SM-3-249190
REV. C.
CARD 7

DATE	BY	DESCRIPTION
12/14/51	PH-51-93	RECEIVER RADIO R390A/URR SCHEMATIC DIAGRAM
4/28/56	PH-51-93	RECEIVER RADIO R390A/URR SCHEMATIC DIAGRAM

DEPARTMENT OF THE ARMY
SIGNAL CORPS ENGINEERING
LABORATORIES
FORT MONMOUTH, NEW JERSEY
SM-J-249190

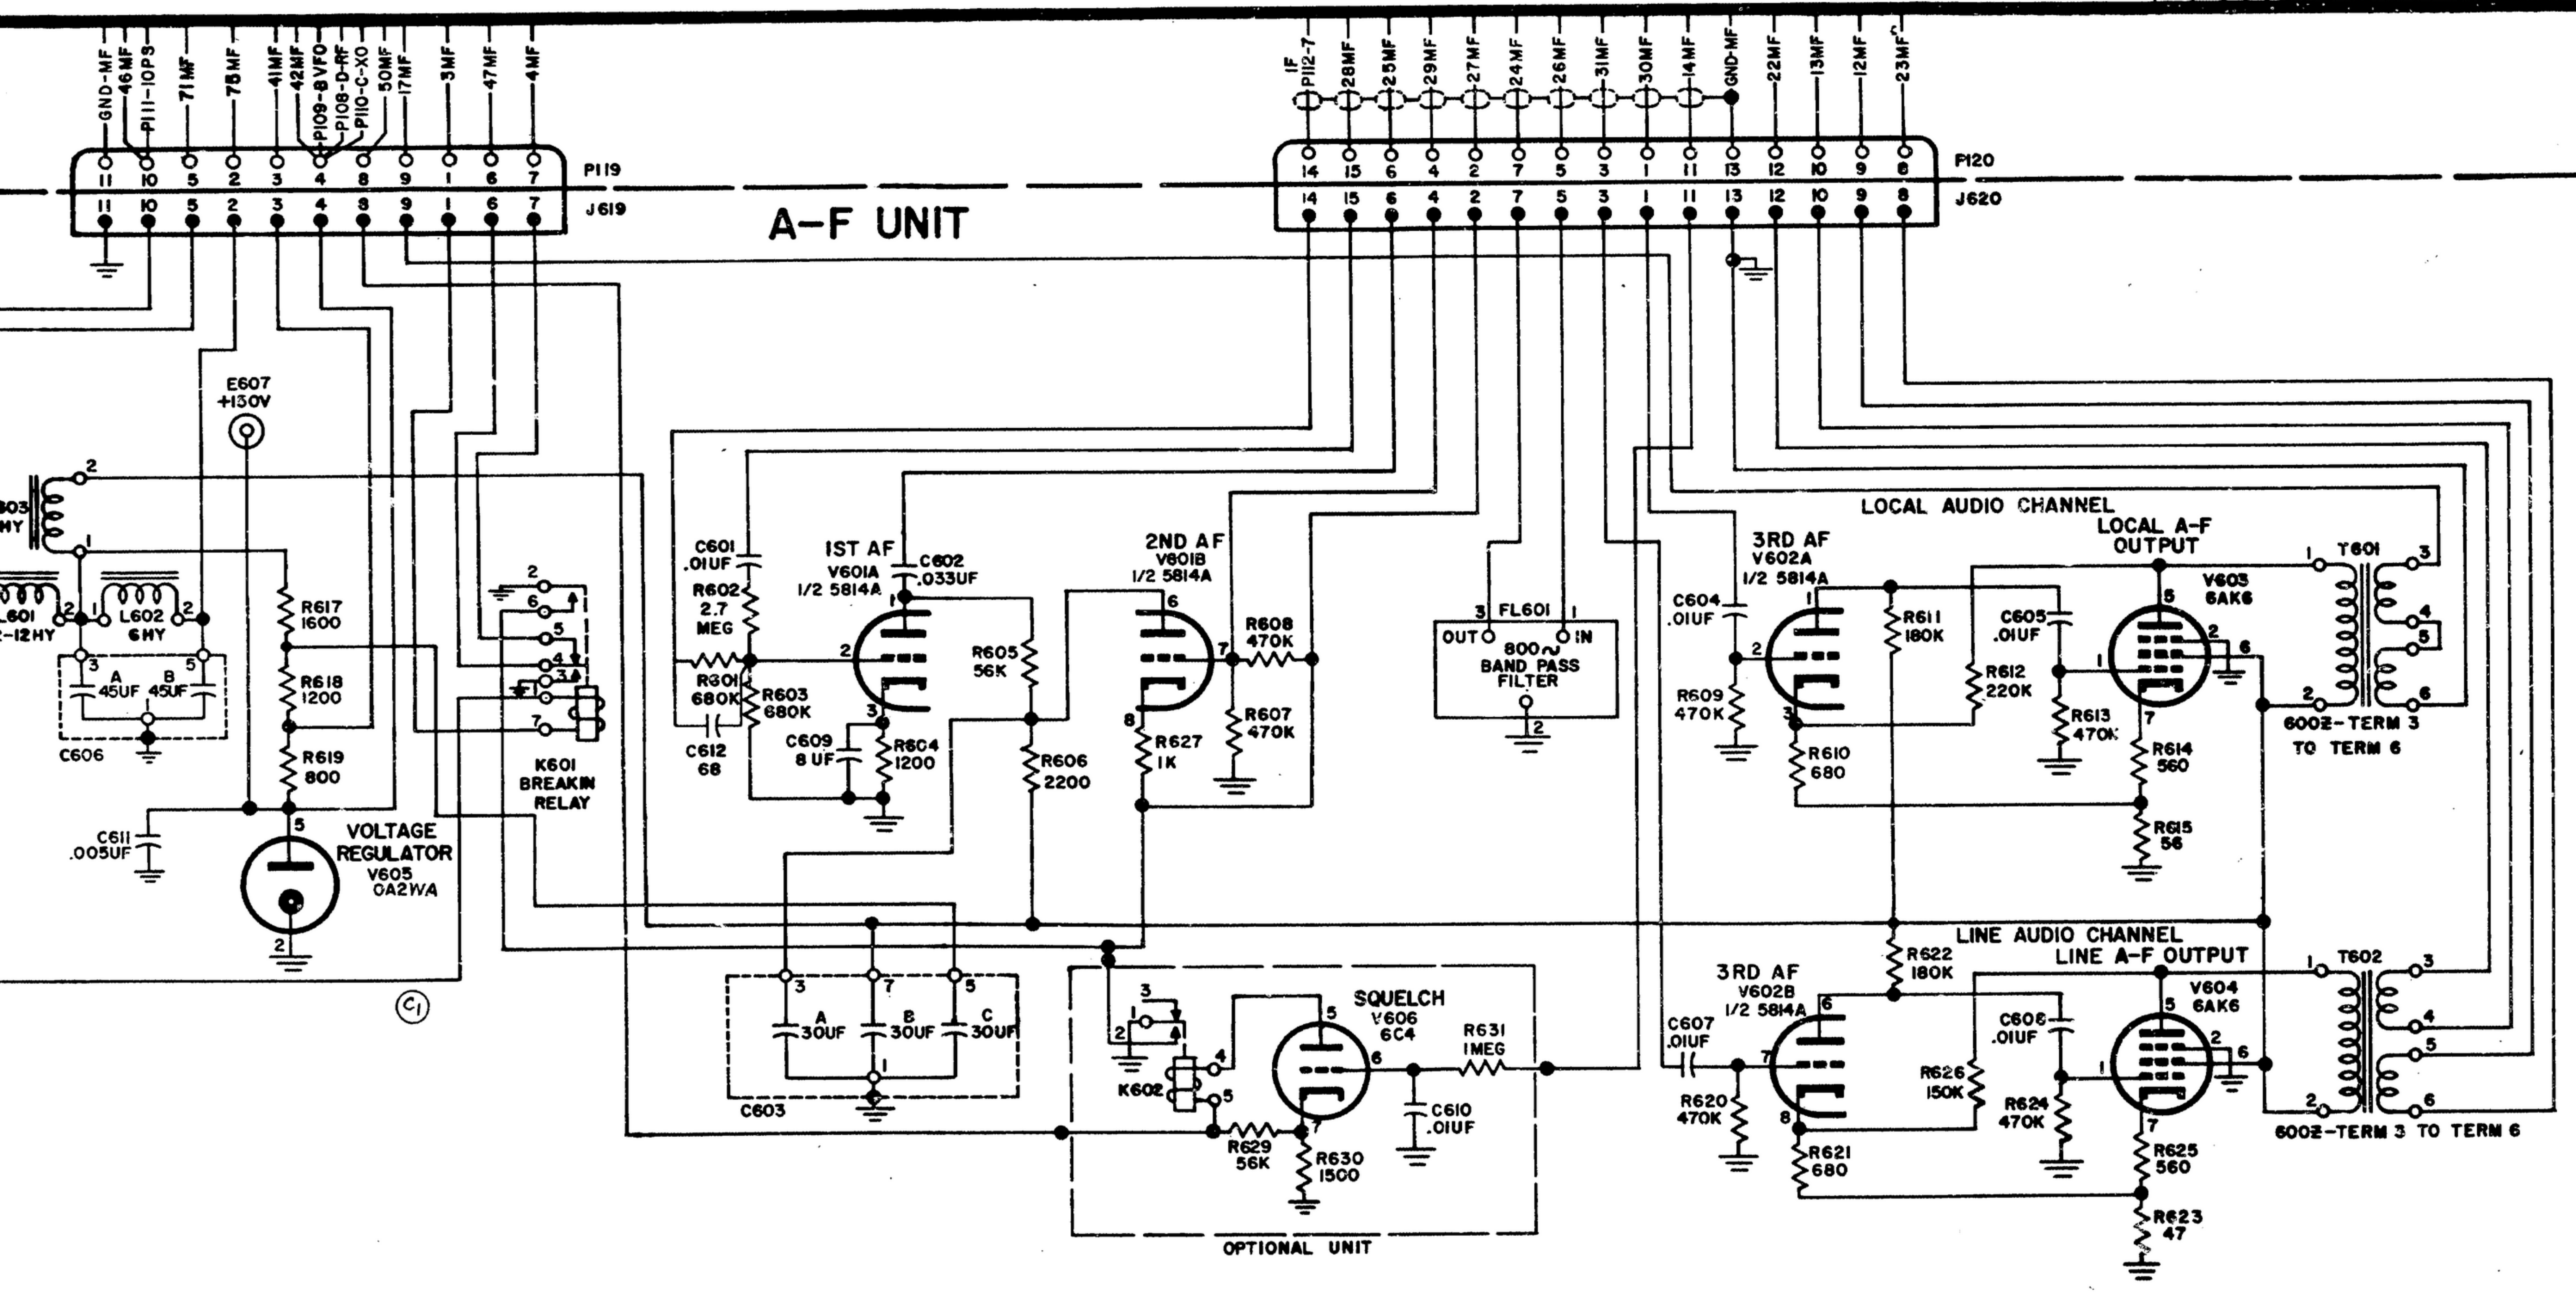
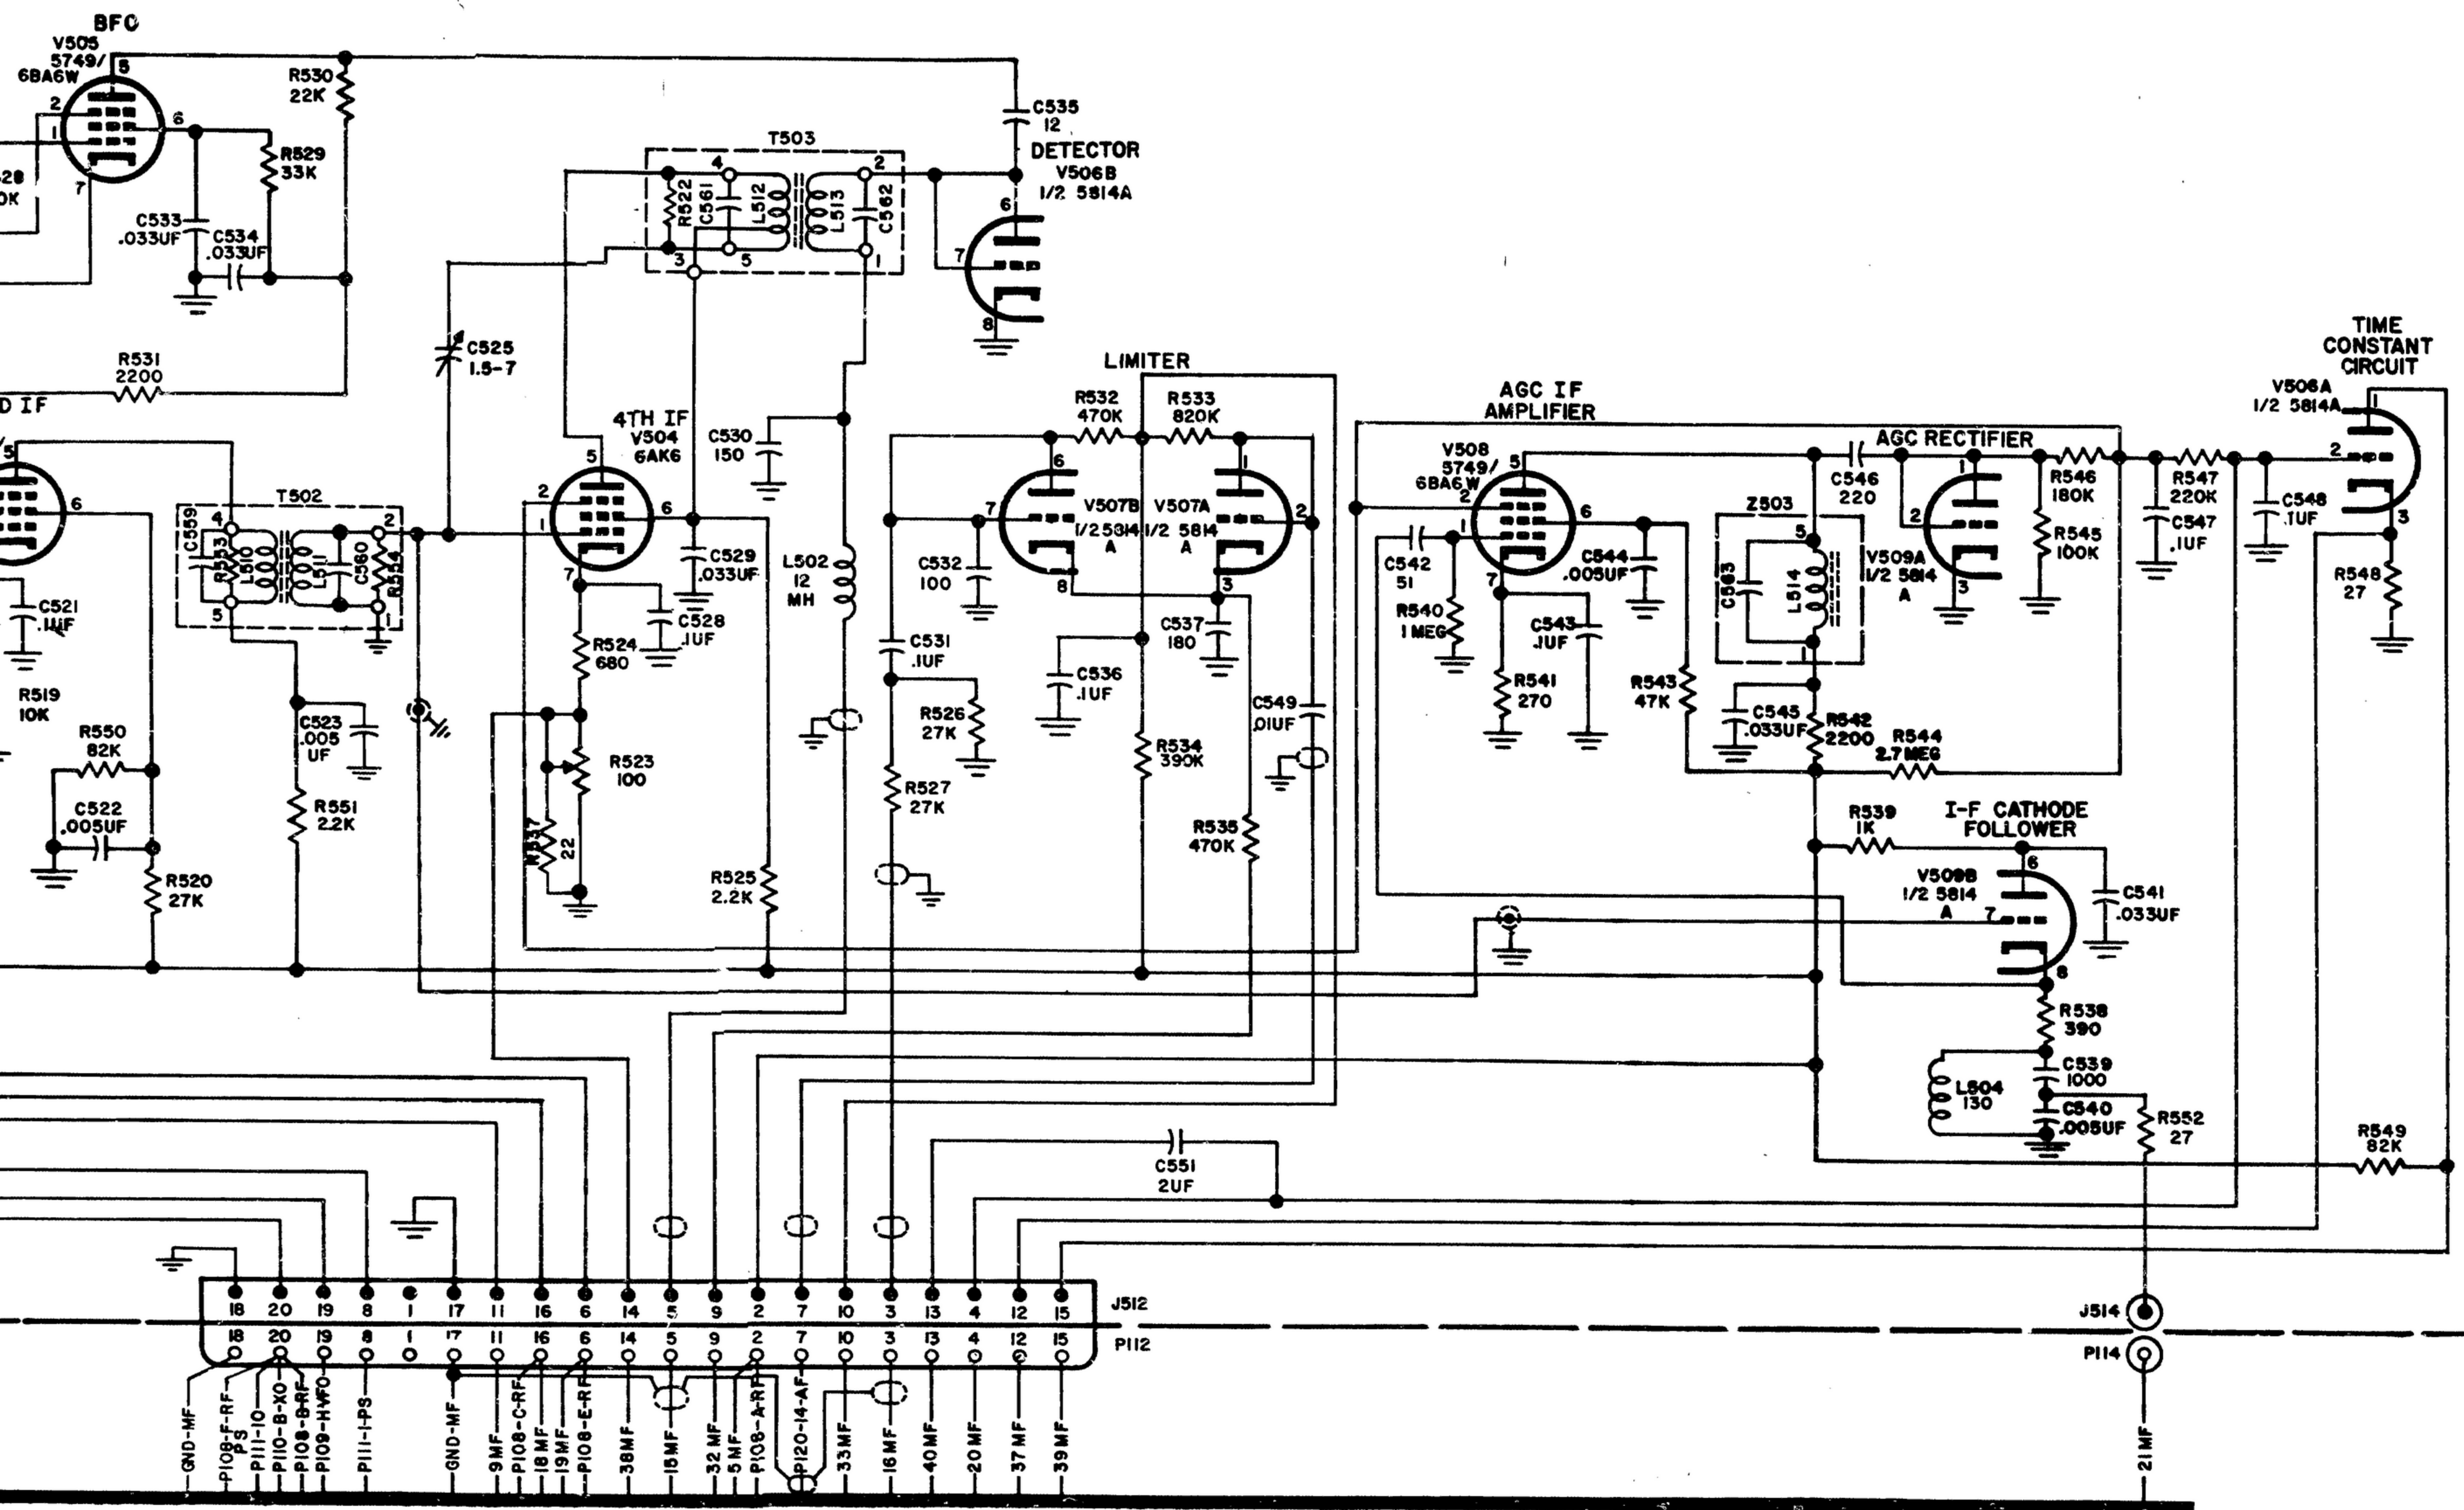
SYMBOL	DESCRIPTION	DATE	APPROVAL
A	(1) 76MF WAS "PI9-5-AF" (2) REMOVED "PI9-5-AF" (3) ADDED: "PI11-5-PB-70" "PI10-A-XO-72" "PI08-K-ER-73" "PI09-A-VFO-74" "PI19-2-AR-75" "PI15-5-AR-71" FUSES "PI02" & "PI03" (4) 78MF WAS "PI9-2-AF" "74MF WAS "PI9-2-AF" "72MF WAS "PI9-2-AF" "71MF WAS "PI11-5-08" "75MF WAS "PI9-A-VFO" (5) REMOVED: "PI9-A-VFO" "PI08-K-ER" "PI10-A-XO" "51" WAS "52" (6) ADDED: "ON" "OFF" "CALIBRATOR OSCILLATOR" "100 KC MULTIVIBRATOR" "100 KC CATHODE FOLLOWER" "6ND ME" (7) "PI15-PB-70" WAS "PI15-PB-70" (8) "77MF WAS "34MF" "78MF WAS "35MF" (9) REMOVED "PI11-5-PB" (10) REVISED REAR VIEW OF SWITCH "620"	7 FEB 61	44429-PC-59
B	(1) C-542 WAS 47 " S.W.F. C.A. 88262	27 OCT 61	REF: PME
C	(1) ON Y605 REF DESIG O22 WA WAS O22.	30 MAR 1965	REF: R-41 REF: R-41 REF: R-41
